January 23, 2023
Sent via email

Mid-Canal Storage Project (PROJECT)
MITIGATED NEGATIVE DECLARATION (MND)
SCH# 2022120628

Notice of Completion & Environmental Document Transmittal
Mid-Canal Storage Project
SCH# 2020060267
Riverside County

SUBJECT: NOI to Adopt an MND for the CVWD Mid-Canal Storage Project

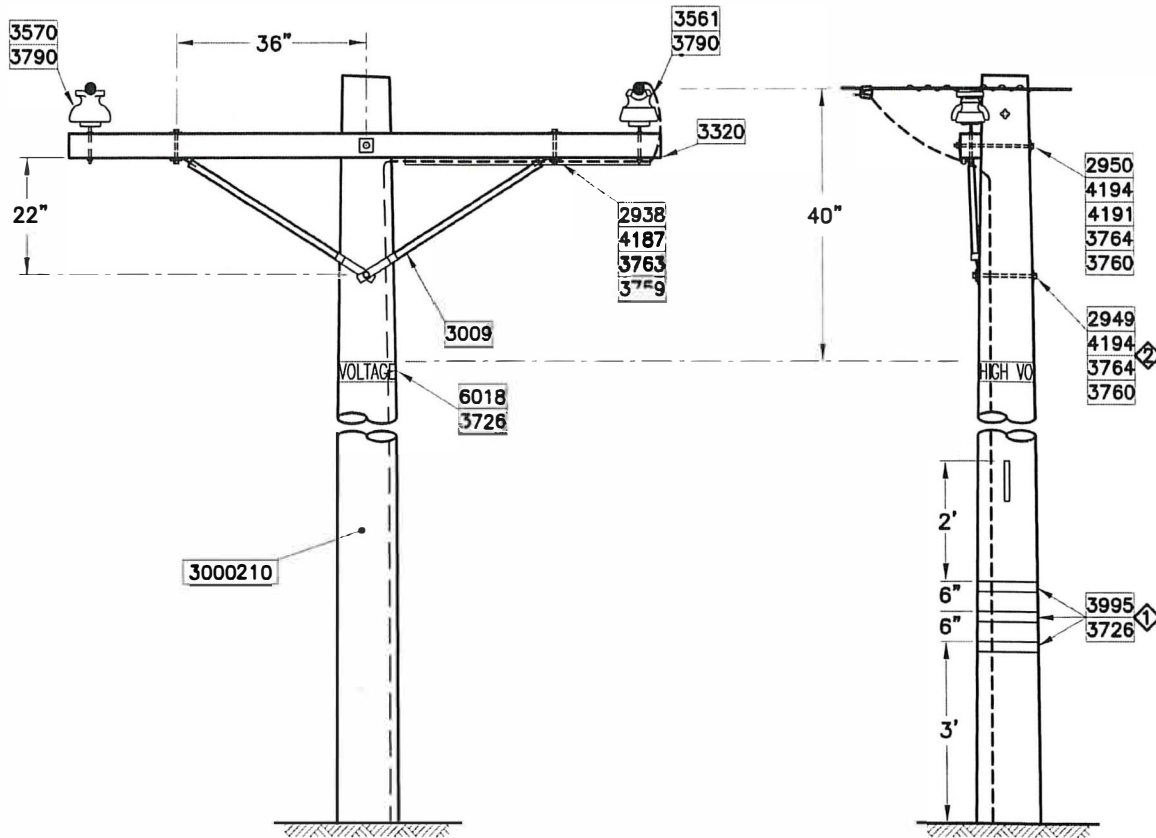
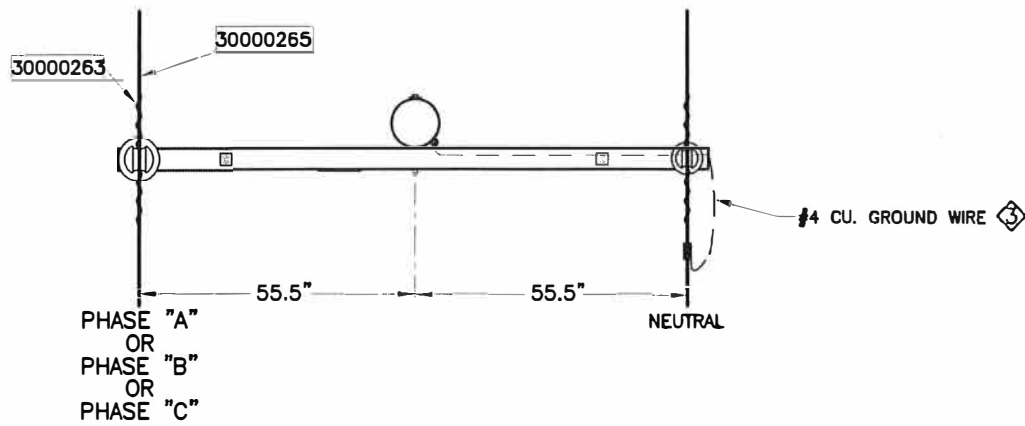
- Please see attached photo of intersection with IID transmission lines and overhead single-phase primary pole standard details, that include guying, head guy pole guying and customer meter pole detail. 1

New single-phase primary line extension would need to cross under the IID's existing "KN&KS" 230kV and "N" 161kV transmission lines and proceed in a north westerly direction along the north side of the Coachella Canal Road right of way.
